3. Folz Subdivision 2023 Replat; KPB File 2023-085R1 McLane Consulting Group / ZPA, LLC Location: Seward Highway Bear Creek Area

ITEM #3 - PRELIMINARY PLAT FOLZ SUBDIVISION 2023 REPLAT

KPB File No.	2023-085R1
Plat Committee Meeting:	April 8, 2024
Applicant / Owner:	ZPA LLC / ANCHORAGE, AK
Surveyor:	James Hall / McLane Consulting Inc.
General Location:	Bear Creek Area

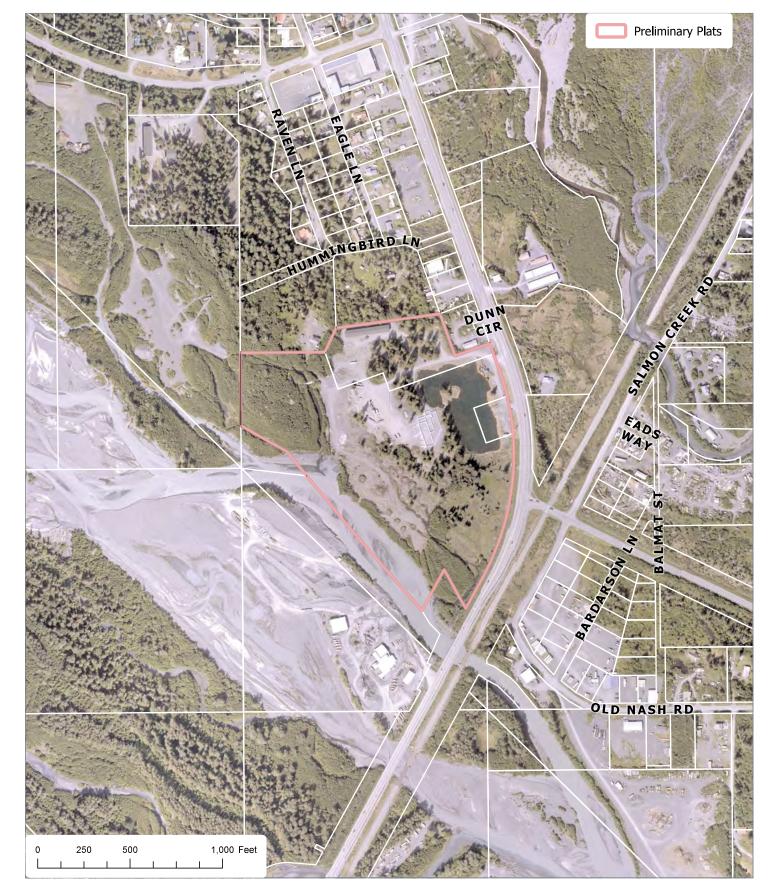
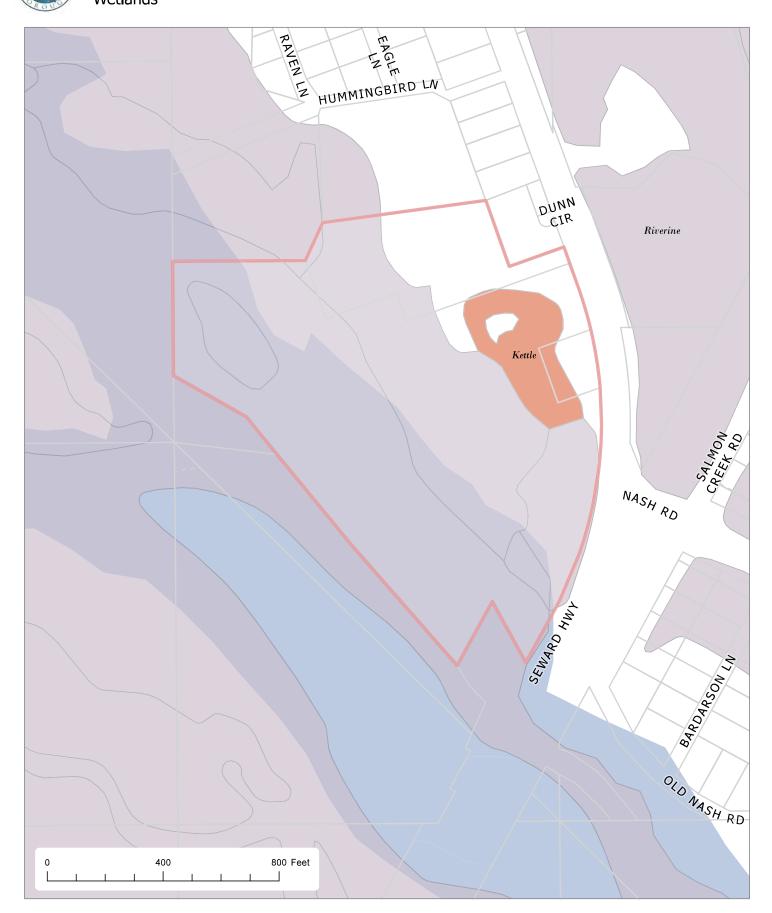
The plat is proposing a private cul-de-sac with a public turn around at the entrance to be dedicated to the Borough. This is a requirement of 20.80.020.C as part of Chapter 20.80 Private Streets and Gated Communities. The three notes of 20.80.020.F are listed at 13, 14 and 15. A Certificate of Acceptance with dedication to the Borough for the turnaround needs to be added to the final.

The plat is affected by a section line easement running north / south through the property. A portion was vacated by KPB Resolution 2017-13 but the part lying north in Tract B & C was not vacated. **Staff recommends:** the surveyor verify if the section line easement still exist and if so, show on the plat.

There are improvements on the property. There is a structure located on proposed Tract E5 and one on proposed Tract E8. There appears to be a structure from the neighboring Tract F2 to the north possibly encroaching on to proposed Tract E5. **Staff recommends:** when doing the field survey, the surveyor watch for any encroachment issues and note them on the final.

- Line type for the flood zone looks to be a fence line, staff recommends to use a different type line and show it in the legend.
- Label the witness corners that are not labeled as WC.

Tie the subdivision to the nearest BLM / GLO Corner.

Need to change the KPB File number to 2023-085R1

Address of owner per Assessing information only has 1120 Huffman Rd, Anchorage, please verify address.

- On Folz Subdivision, Snowden Addition SW98-33 in the ROW of Seward highway at Tract E1 and Tract
 C there appears to be a jog in the right-of-way of 4 feet, please verify. State of Alaska Right-of-way
 map Project No ERFO-5(1) looks to show a jog also.
- The section line easement running north/south was vacated by Resolution 2017-13 south of Tract C, need to show easement running north.
- E. All parcels of land including those intended for private ownership and those to be dedicated for public use or reserved in the deeds for the use of all property owners in the proposed subdivision, together with the purposes, conditions, or limitations of reservations that could affect the subdivision;

Need to get with Addressing to get a name for the private road. Name should have been obtained prior to submittal, to be approved by Plat Committee.

Tract H to the west needs labeled and a line between Tract G & H added

There appears to be encroachments along the northwest line, verify and report to staff.

Need to add a Certificate of Acceptance to the Borough for the turn around

Need overall data on lines

Show a distance across the straight portion of the flag lot for reference.

Show measured and recorded data.

Add the date of April 8, 2024 to the Plat Approval

Verify the address of the members signing.
